# **Hydrologic Aspects of the Updated Addendum to the Environmental Impact Statement for the DPM Lead-Zinc Mine, North Sumatra, Indonesia**

Steven H. Emerman, Ph.D., Malach Consulting, LLC, 785 N 200 W, Spanish Fork, Utah 84660, USA, Tel: 1-801-921-1228, E-mail: SHEmerman@gmail.com

Submitted on August 4, 2021, Revised on August 8, 2021

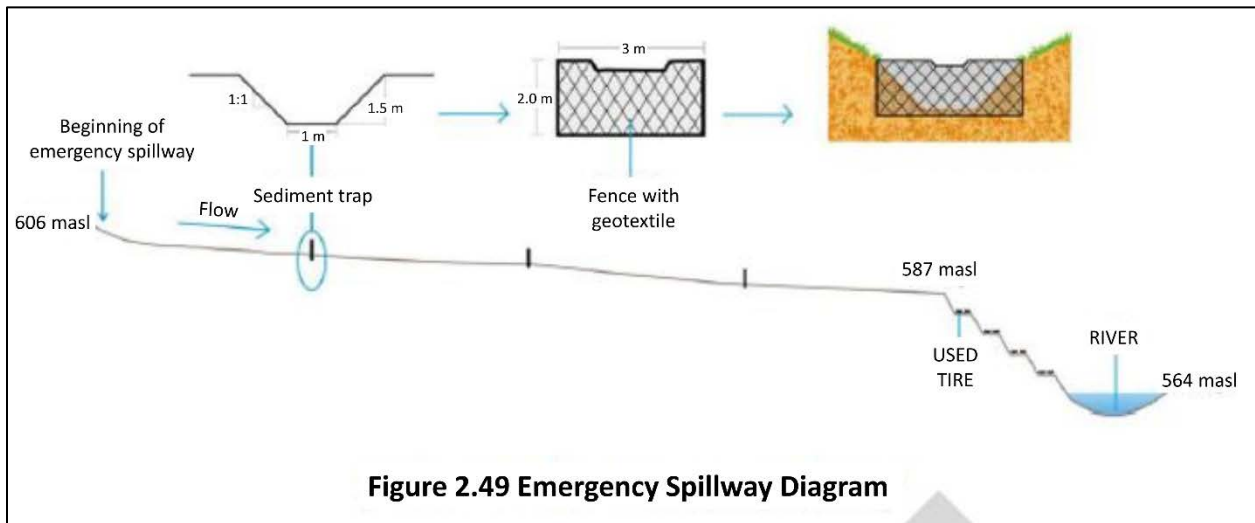
The diagram of the emergency spillway from DPM (2021) (see Fig. 1) clarifies that any tailings pond water that flows through the emergency spillway will enter downstream waterways with no passive or active treatment for the removal of contaminants. The only treatment will be the removal of sediment (fine tailings) due to the passage of the spillway flood through a sediment trap, which would be only a geotextile fence across a constructed channel (see Fig. 1). There is no discussion in DPM (2021) of the circumstances under which obstruction of the flow by the geotextile will cause overtopping of the fence and/or the banks of the constructed channel

followed by entry of the tailings pond water into downstream waterways without even any sediment (fine tailings) removal. There is also no discussion of the time that will be required for the geotextile to become clogged with fine tailings or any procedures for cleaning or replacement of the geotextile. Of course, once the geotextile becomes clogged, there will be a continuous overtopping of the fence and/or the banks of the constructed channel. Finally, there is no discussion of the dimensions or slope of the constructed channel that should be required to accommodate the overflow that will occur whenever the monthly rainfall exceeds 322.7 mm.

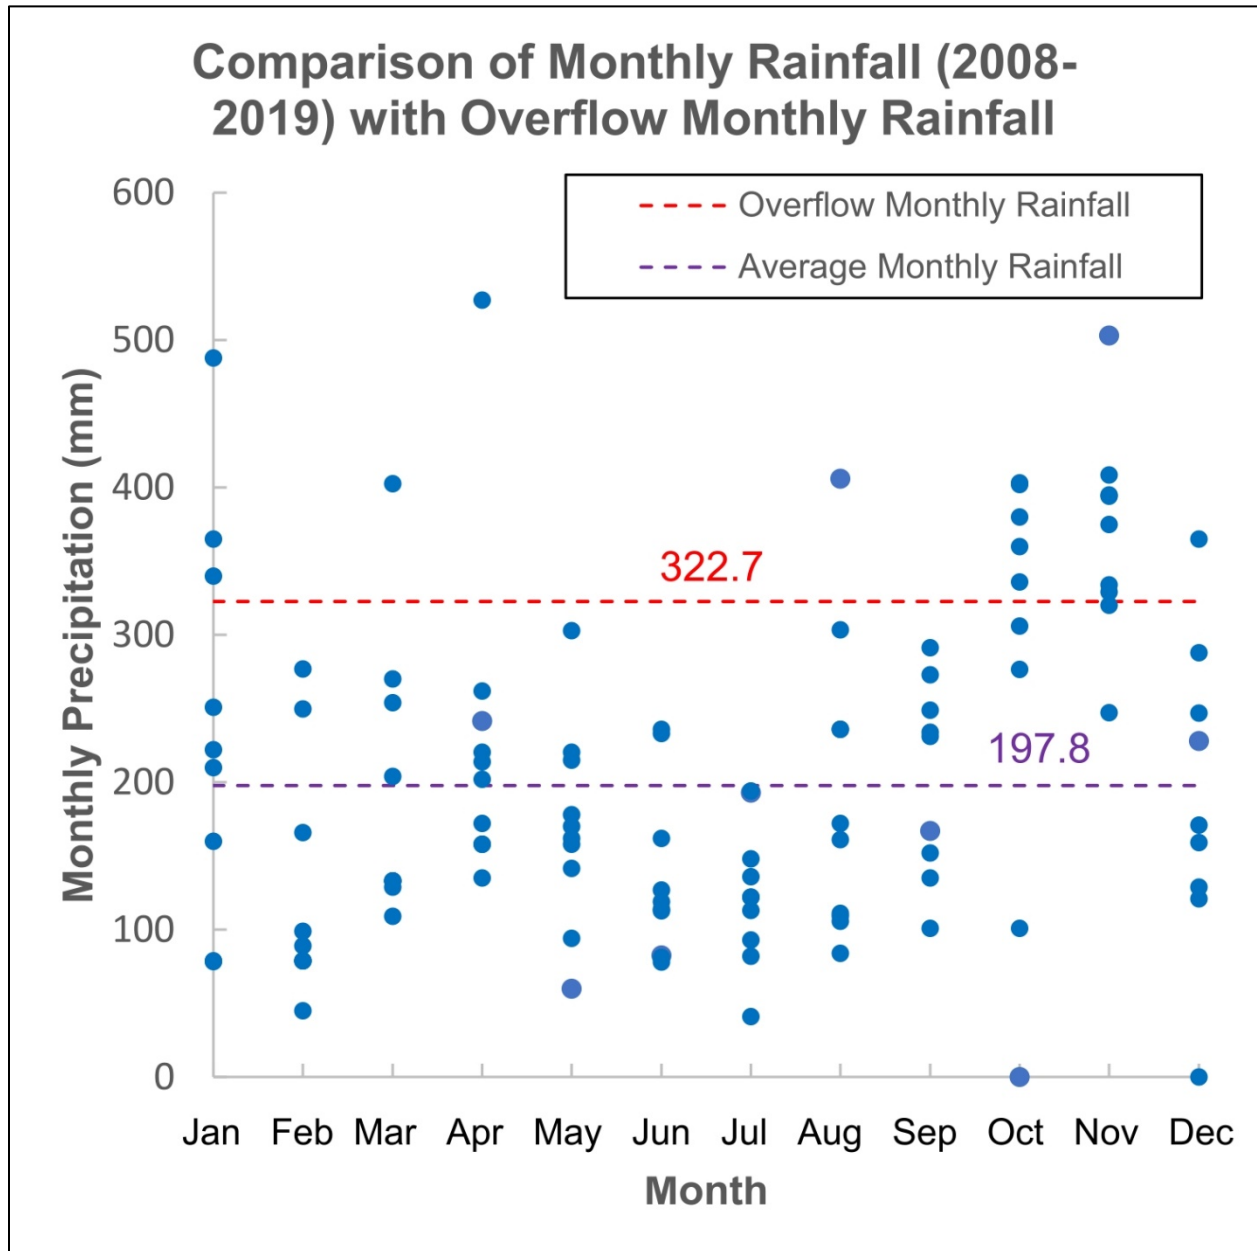
Based on a comparison of monthly precipitation data from the mine site weather station for 2008-2019 (see Fig. 3a) and an overflow monthly rainfall of 322.7 mm, the toxic and acidic tailings pond water will be flowing without treatment into downstream water bodies 20 out of every 137 months, or 15% of the time (see Fig. 6). Such a frequent discharge of untreated mine wastewater into downstream water bodies must be regarded as unacceptable by any standard. The basis for the overflow monthly rainfall of 322.7 mm is the statement “*diketahui bahwa pada tahun 2009 hingga tahun 2018, curah hujan rata-rata tertinggi tercatat pada bulan November yaitu 322,7 mm*” [it is known that from 2009 to 2018, the highest average rainfall was recorded in November, which was 322.7 mm]. However, based on the data in Table 4.7 of DPM (2021) (see Fig. 3a), the average monthly rainfall for November for 2009-2018 was 328.7 mm, while the average was 344.5 mm for 2008-2018 (the highest November rainfall was 503 mm in 2008). There is no explanation in DPM (2021) as to how the overflow monthly rainfall could be set so precisely (to the nearest 0.1 mm).
